Analysis of Nova Scotia Power's 2020 Integrated Resource Plan

Recommendations on Key Findings, Action Plan,
and Roadmap Elements

**Prepared for Counsel to Nova Scotia Utility and Review
Board**

December 23, 2020

Figure 1. Carbon Emissions by Selected Scenarios – 2.1C, 2.1C Low Wind, 3.1C – 2021-2045

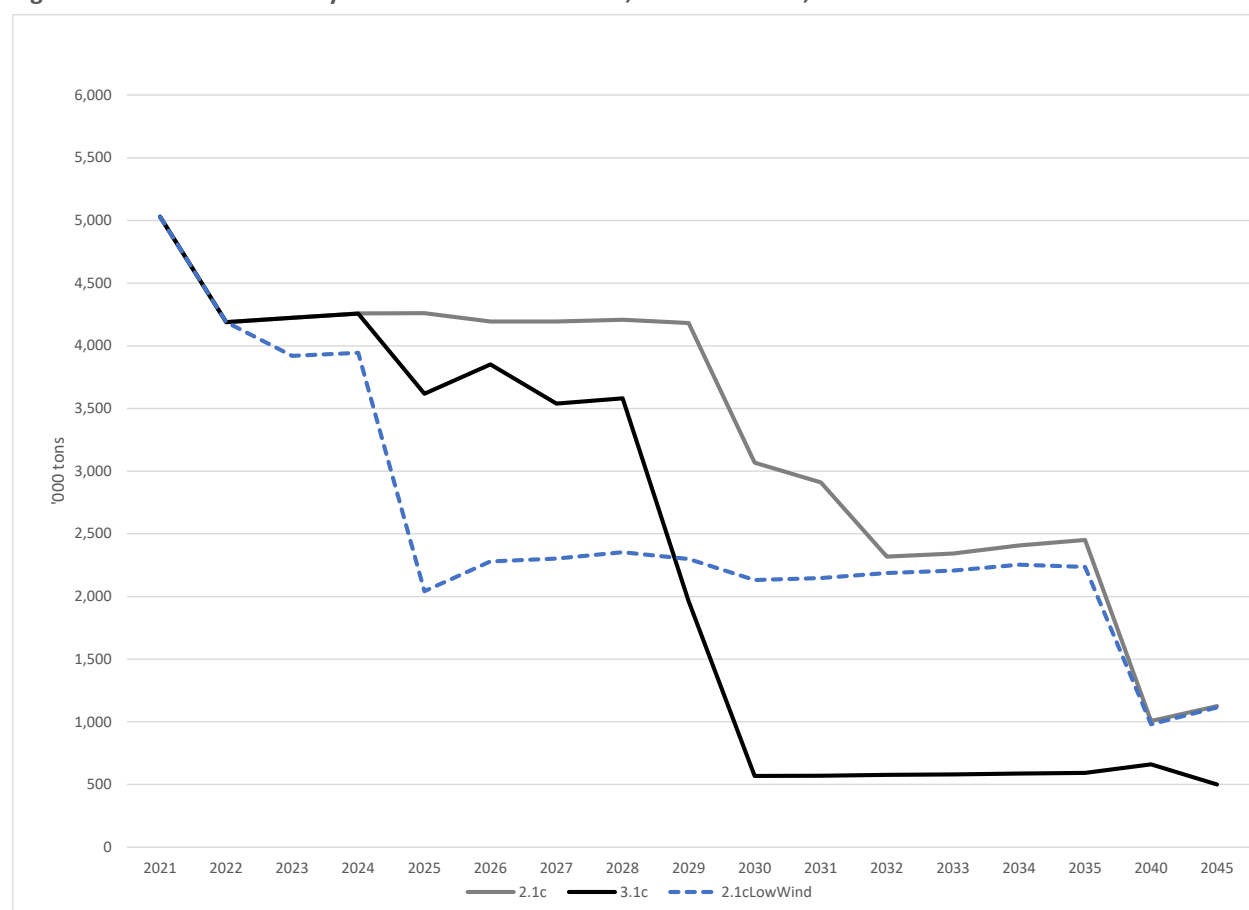
Figure 1 below reproduces the emission trajectory results shown in Tables 1 and 2 above. It shows the different CO₂ trajectories for three Scenarios: 2.1C, 2.1C low wind cost, and 3.1C.

For any comparison made between scenarios, if there is a difference in CO₂ emissions then the scenario with the lower level of emissions will result in a relative reduction in overall revenue requirements (compared to NSIP’s modeled NPVRR), if it is assumed that overcompliance with the SDGA’s emissions limits for NSPI can be monetized through the sale of carbon reduction credits. This applies for any factor that lowers emissions, not just earlier wind installations or earlier coal plant retirement. As another example, valuing incremental carbon emission reduction from increased levels of DSM can be estimated by comparing two scenarios with different levels of DSM, where the scenario with more DSM leads to lower energy needs and lower CO₂ emissions.

One key observation seen in Table 1 above is that the order of magnitude of additional carbon reduction value for scenarios with earlier wind investment (the baseline Scenarios 2.1C vs. 2.1C “low wind”) is roughly \$250 million (NPVRR) if all of the incremental CO₂ emission reduction is valued at the June 2020 Cap and Trade clearing price of \$24/ton. And, when considering the effect between earlier (by 2030)

and later (by 2040) coal steam plant retirement, seen in Table 2 above (Scenario 2.1C vs. 3.1C) the carbon reduction value is roughly \$374 million, also assuming a value of \$24/ton for all incremental CO₂ reduction.

Based on the above discussion concerning incremental carbon emission reductions, we recommend consideration of a retirement path that looks to close all units in the earlier part of the planning horizon, closer to 2030 than 2040. NSPI's Action Plan and Roadmap elements analyzing thermal plant retirement issues (Action Plan item #3 and Roadmap elements #6 and #3) and the overall evergreen process (Roadmap element #8) should continuously review cost and benefit assumptions concerning the retention timeline for the coal units.
